Dealer Service Instructions for:

Safety Recall H07

Tire Pressure Monitoring System Electrical Connectors

2007-2008 (JS) Dodge Avenger and Chrysler Sebring

Figure 1

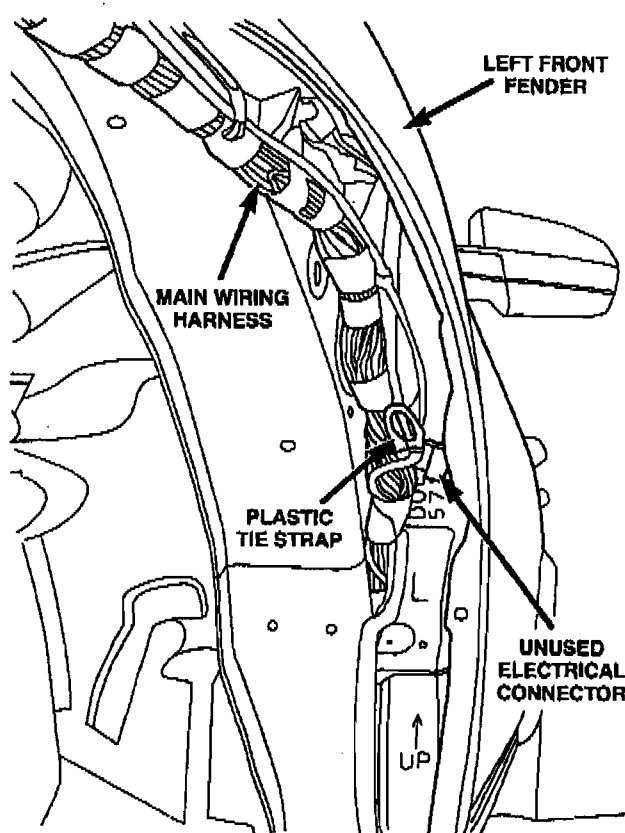
2. Partially lift the vehicle on an appropriate frame contact hoist.
3. Remove the left front wheel and tire.
4. Remove the rear section of the left front plastic inner fender splash shield.
5. Locate the unused 6-cavity tire pressure monitor electrical connector that is tie strapped to the main wiring harness (Figure 1).

6. Cut off and discard the plastic tie strap that holds the 6-cavity unused electrical connector to the main wiring harness (Figure 1).
7. Using diagonal pliers, cut off and discard the 6-cavity unused tire pressure monitor electrical connector (Figure 2).
8. Remove approximately 2 inches (50 mm) of protective tape from the wires cut in Step 7.
9. Place a piece of heat shrink tube over each individual wire end and heat the shrink tube until glue comes out of both ends of the shrink tube (Figure 3).
10. Tape back the sealed wires to the main electrical wiring harness.
11. Install the plastic inner fender splash shield.

Figure 2

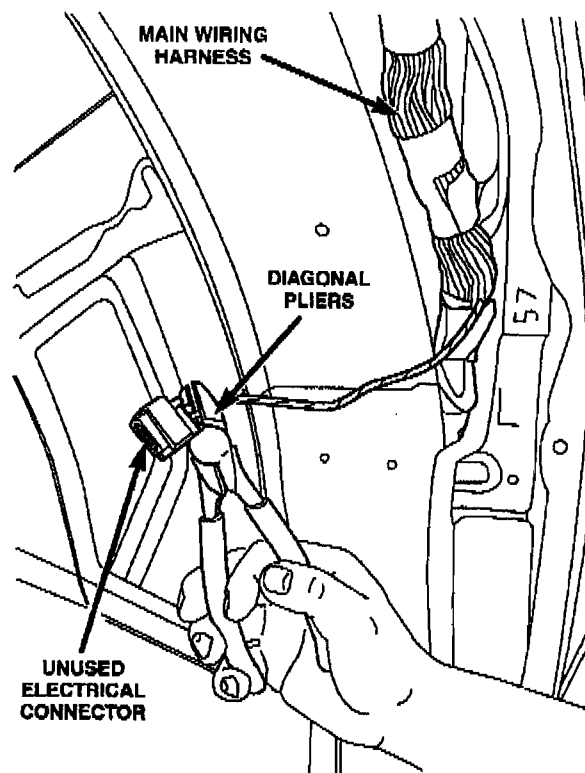
19. Place a piece of heat shrink tube over each individual wire end and heat the shrink tube until glue comes out of both ends of the shrink tube (Figure 2).

Figure 4 – Left Side Shown

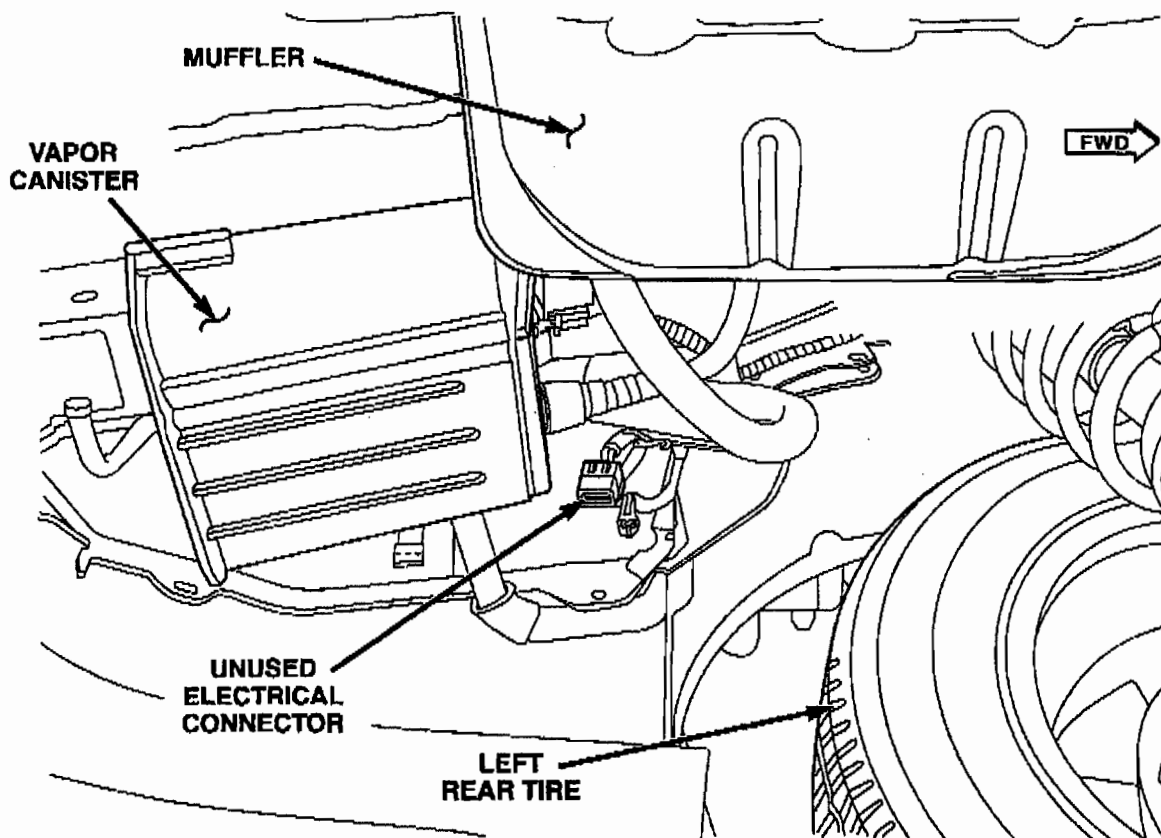
12. Install the wheel and tire assembly. Tighten the lug nuts to 100 ft. lbs. (135 N·m).
13. Lift the vehicle all the way up on the hoist.
14. Inspect the left and right rear wheel well areas to determine if there is an unused **left and right side rear** tire pressure monitor electrical connector (Figure 4).
 - Vehicles with unused electrical connectors, continue with Step 15.
 - Vehicles without unused electrical connectors, continue with Step 22.

15. Cut off plastic tie strap that holds the unused left and right rear tire pressure monitor electrical connector to the body wiring harness.
16. Pull the body wiring harness from the body studs.

17. Using diagonal pliers, cut off and discard the right and left side rear unused tire pressure monitor electrical connectors.
18. Remove approximately 2 inches (50 mm) of protective tape from the wires cut in Step 17.
